**RE: Response to Comments**  
**Modification Request No. 10 – Upgrades at the Mary River Mine Site**  
**Mary River Project, Type 'A' Water Licence - 2AM-MRY1325 - Amend. No. 1**

**Table 1 - Baffinland Response to Comments**  
**Modification No. 10 - Upgrades to the Mary River Mine Site**

**(H353004-00000-221-294-0004-0001, Rev. 0)**

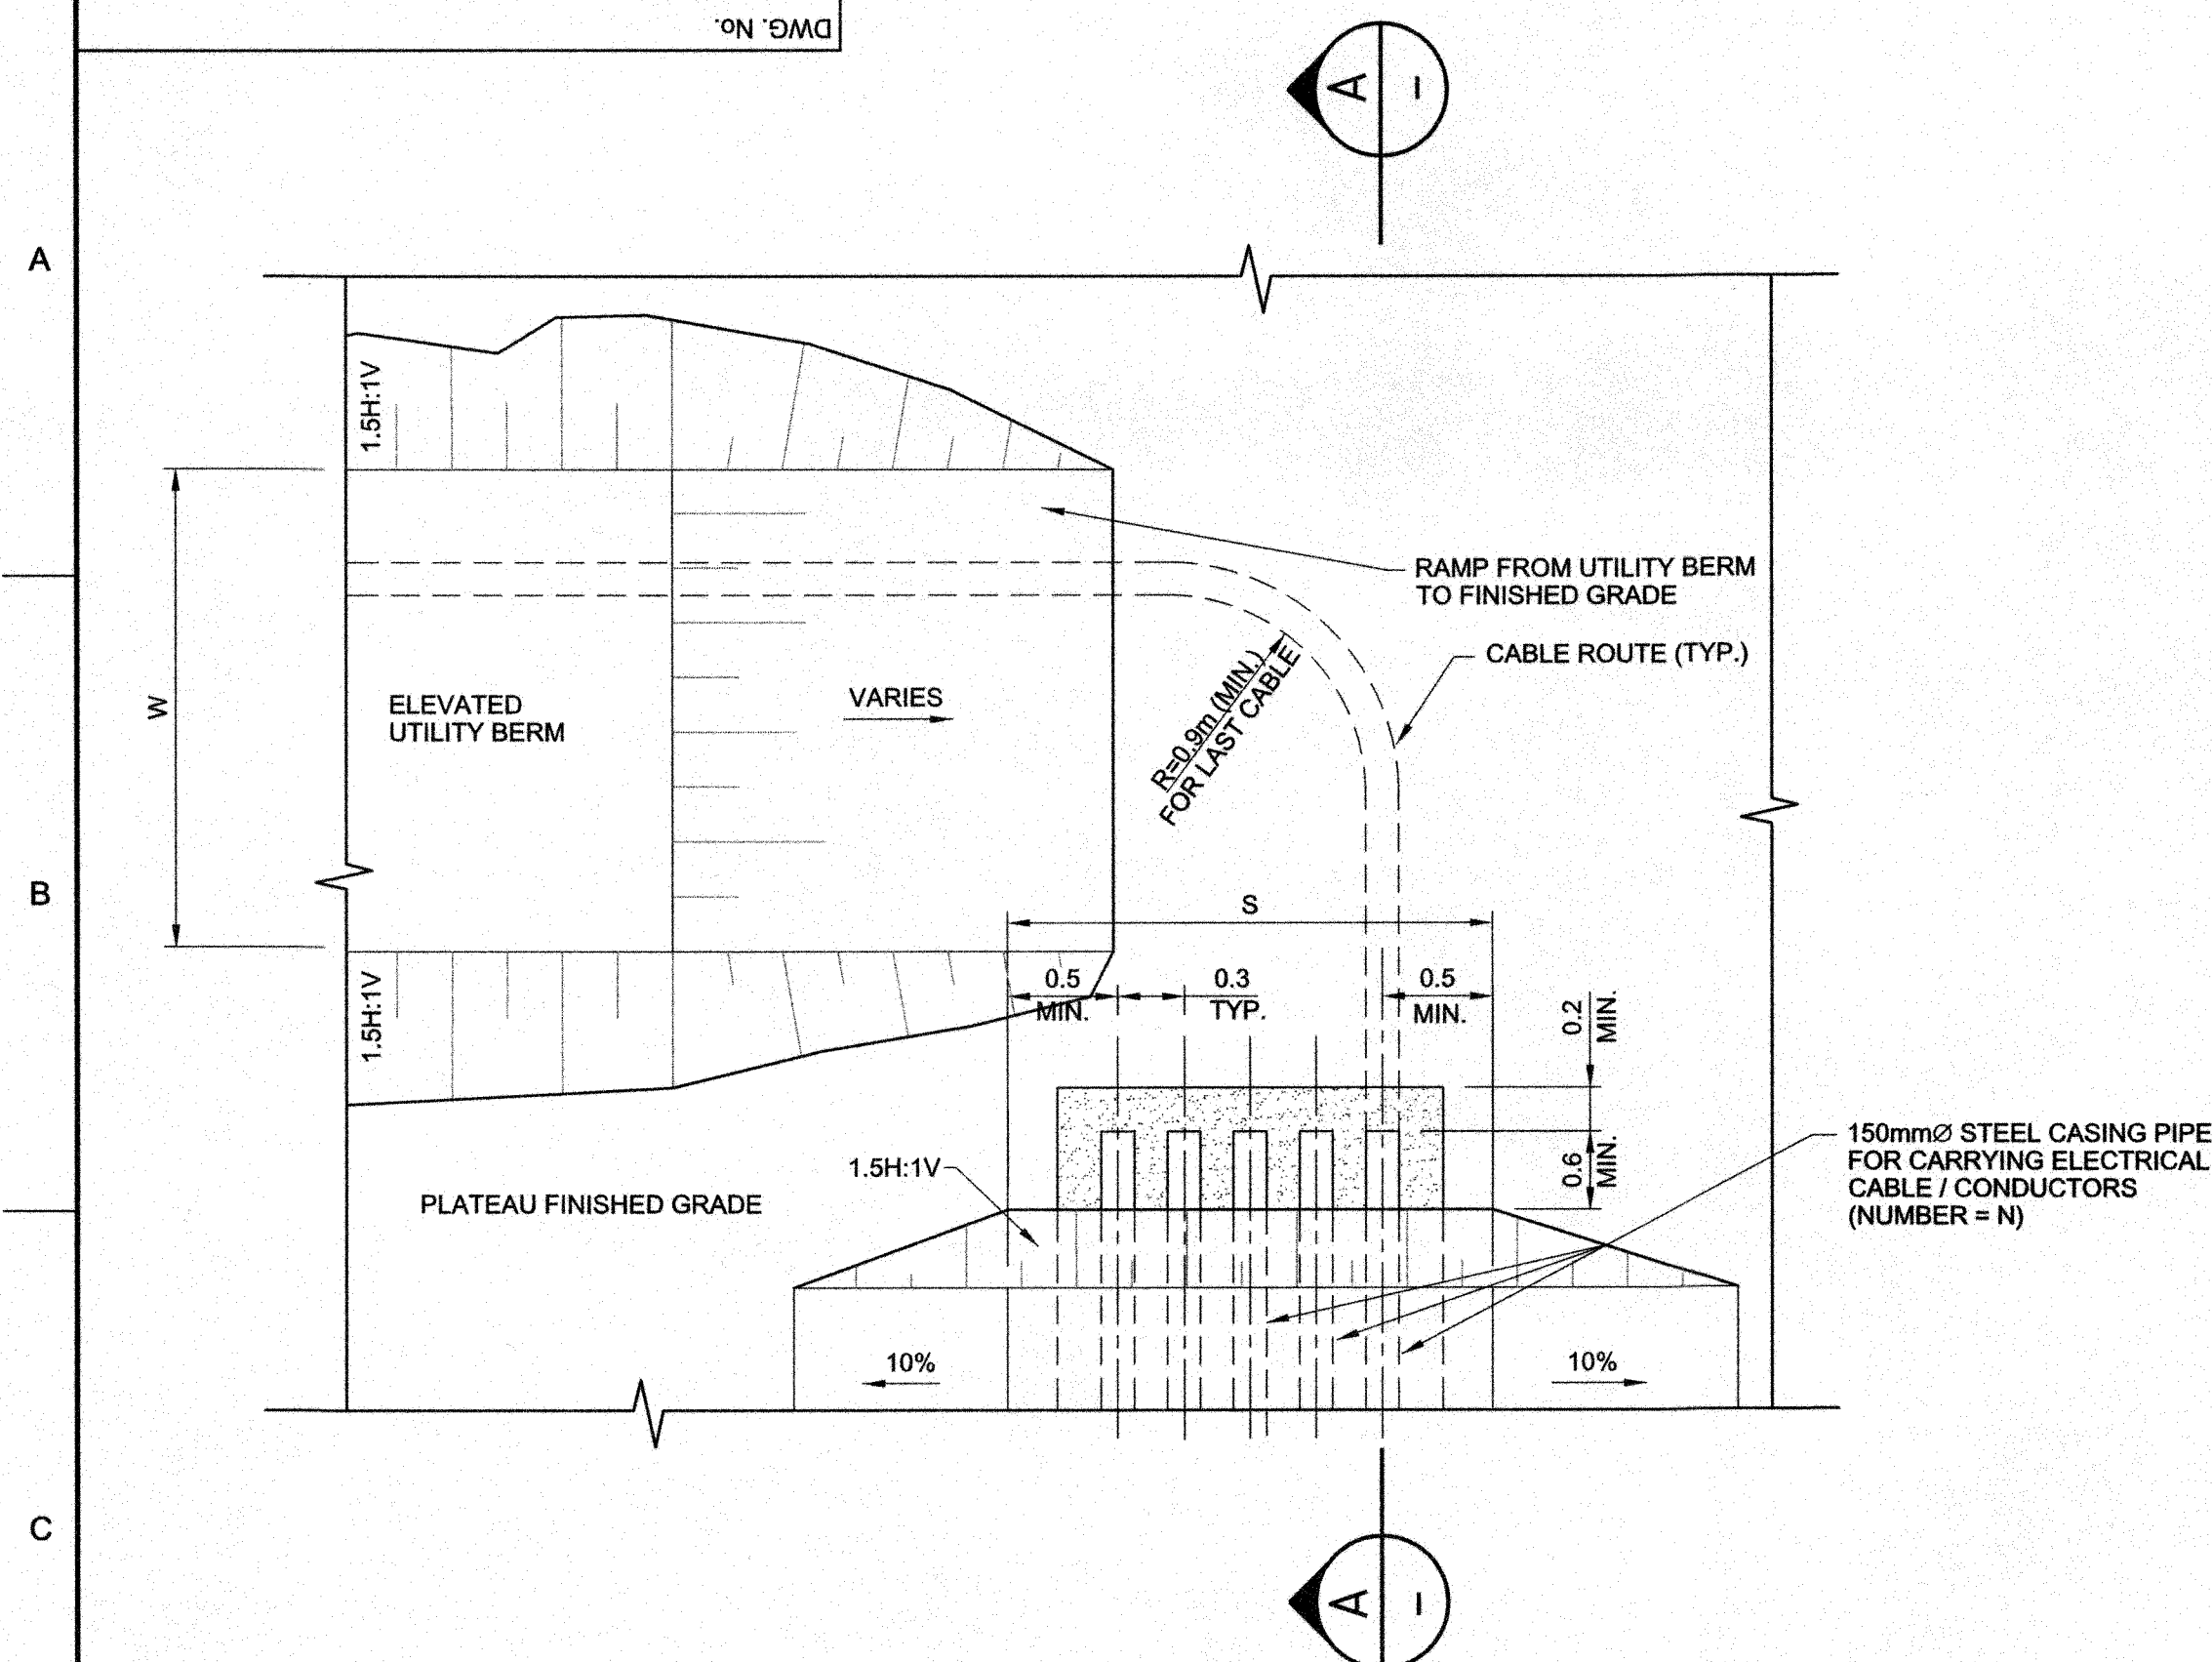
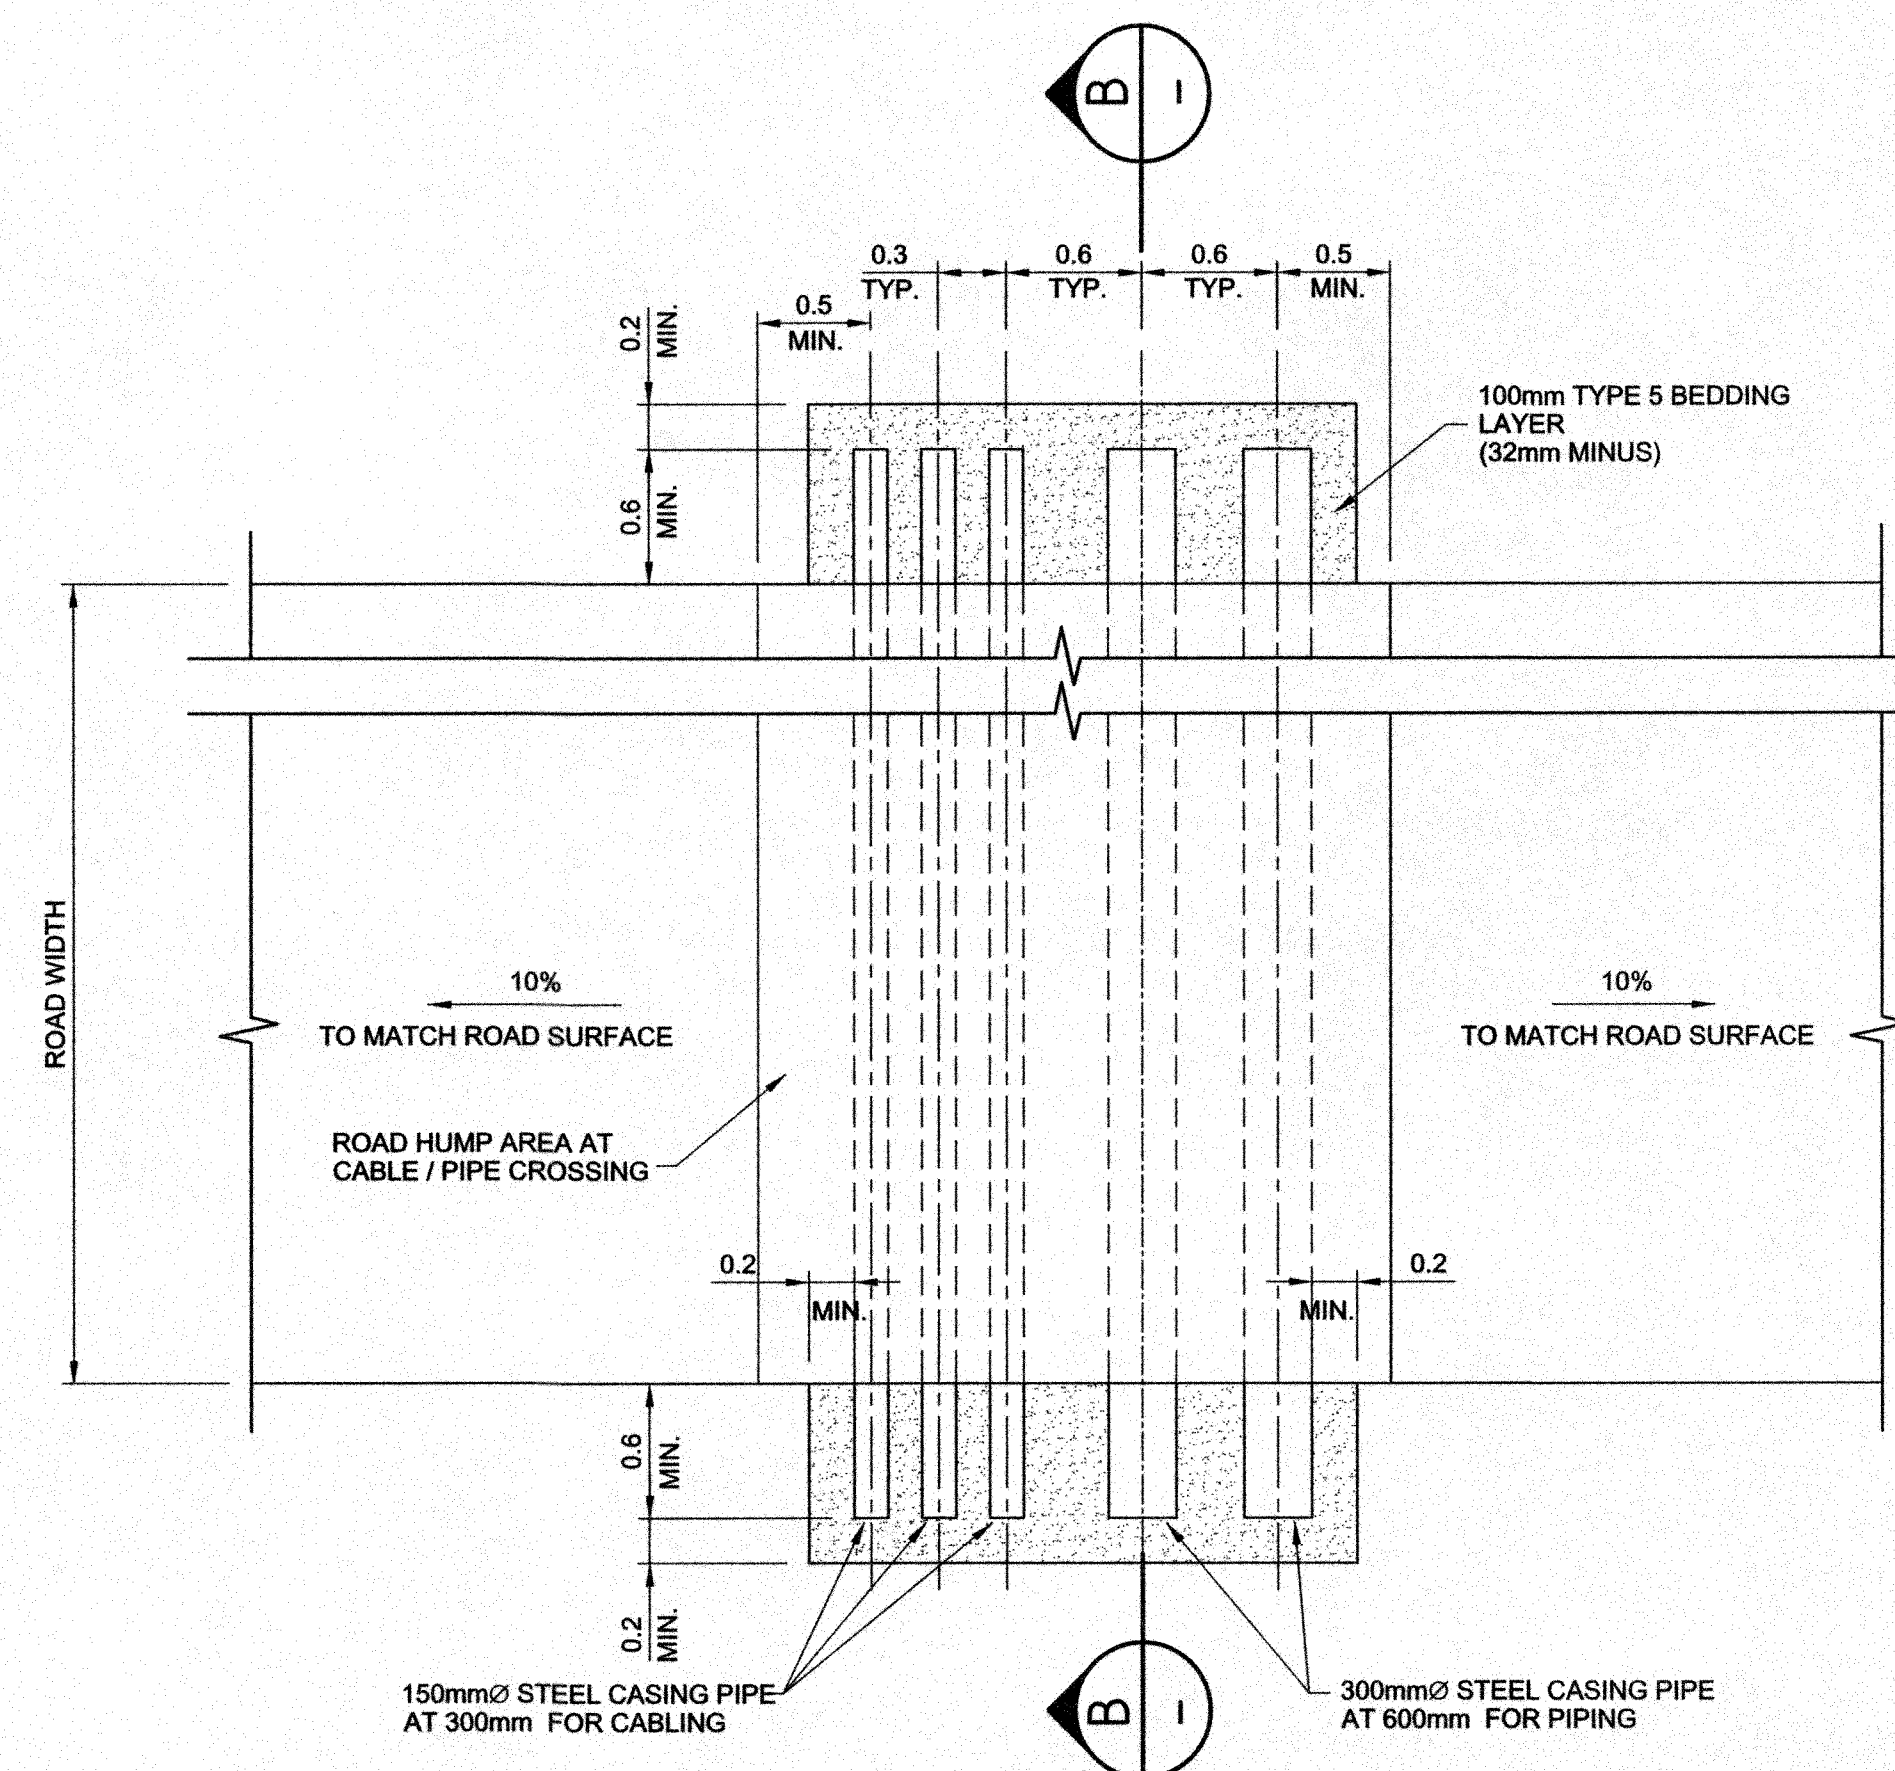
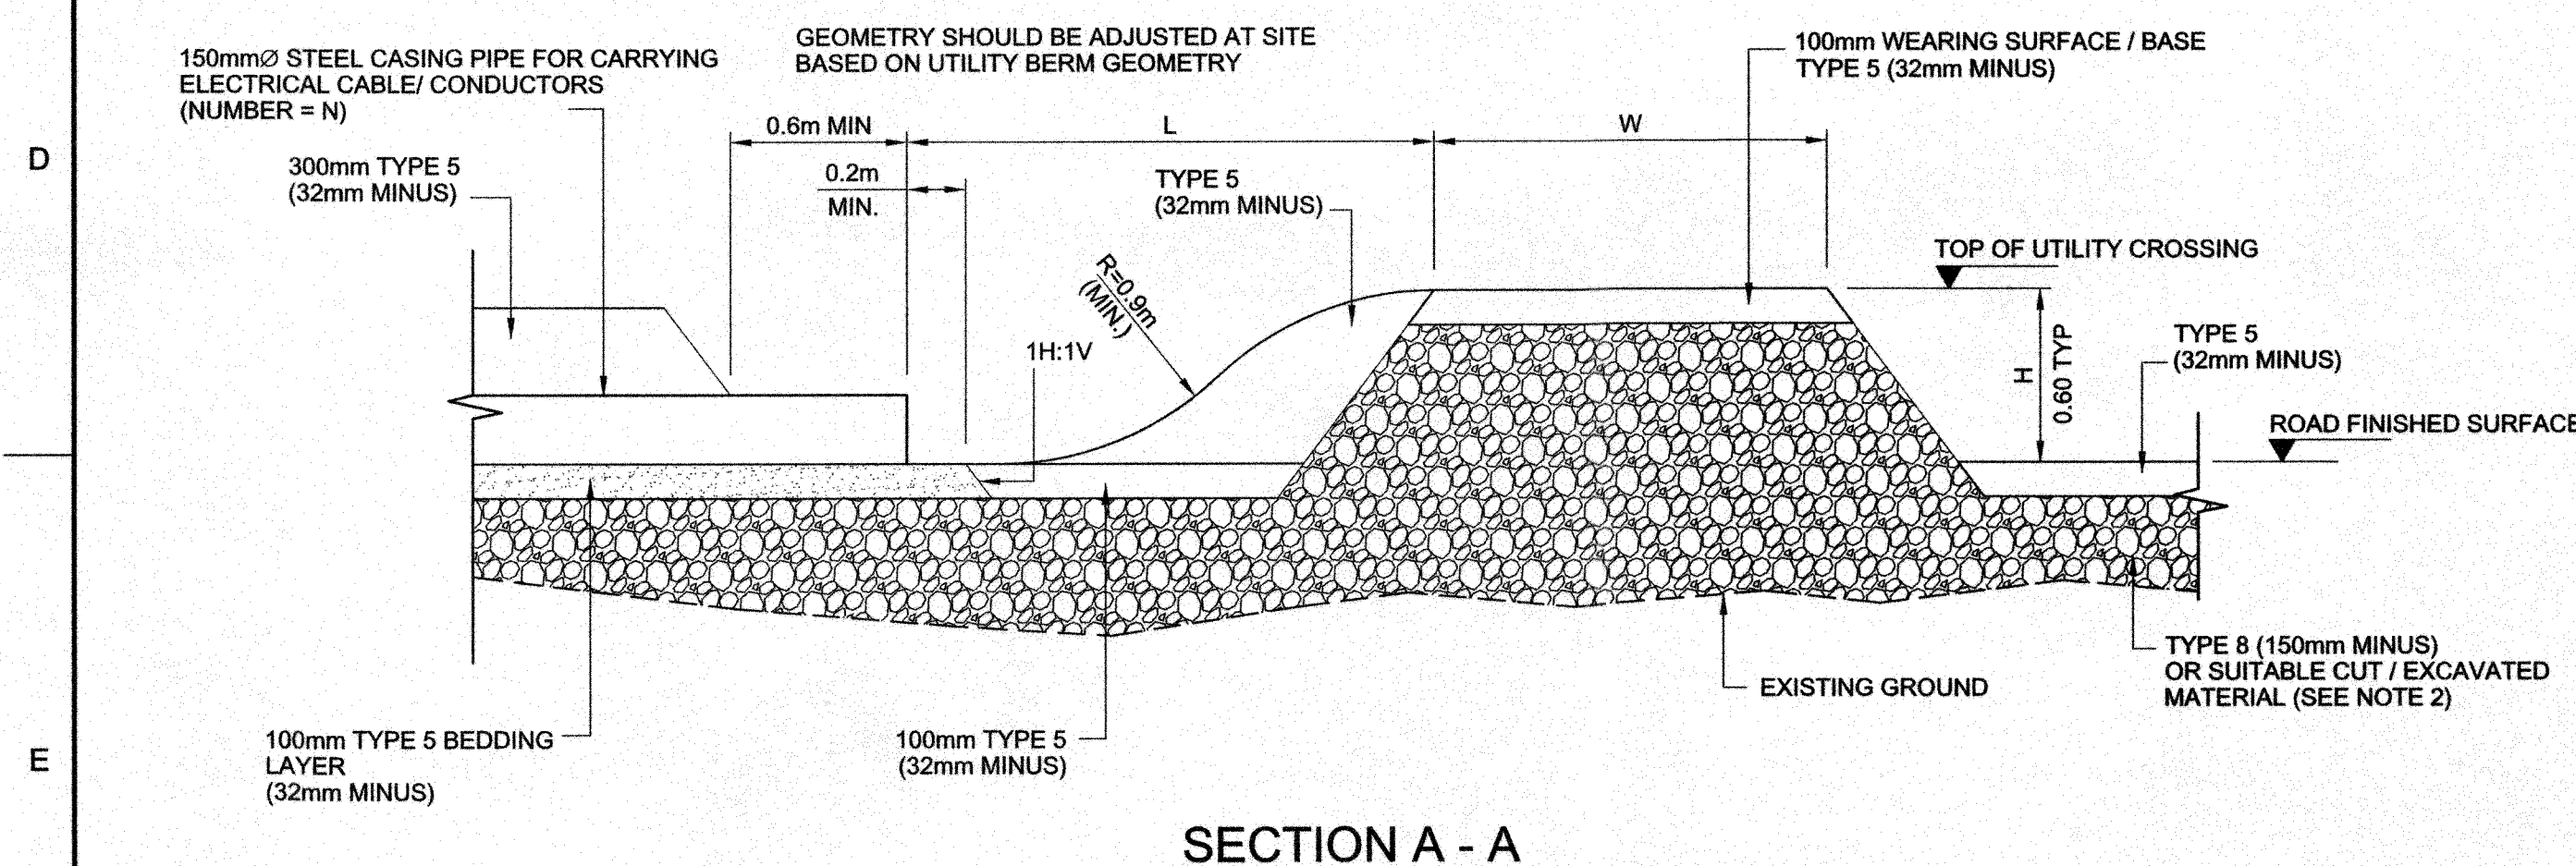
ID	Comment / Recommendation	Baffinland Response
4	<p>Comment:</p> <p>Baffinland proposes to build four (4) culverts to accommodate the crossing of the effluent pipeline across roads. However, specifications and installation details for the culverts are not provided in the submission for Modification Request No. 10.</p> <p><u>Recommendation:</u></p> <p>CIRNAC recommends that Baffinland provide drawings, including specifications showing details (type, material, dimensions, and extensions), for all four culverts, and that an engineer field checks the designs as they are implemented.</p>	<p>To facilitate passage under roadways, the effluent discharge line will be installed within 300 mm diameter steel pipe sleeves, approximately 15m in length. A site wide typical for road crossings of utility corridors is provided in Attachment No. 2, Drawing No. H353004-00000-221-294-0004-0001. All materials will be sourced from approved quarry and borrows.</p>
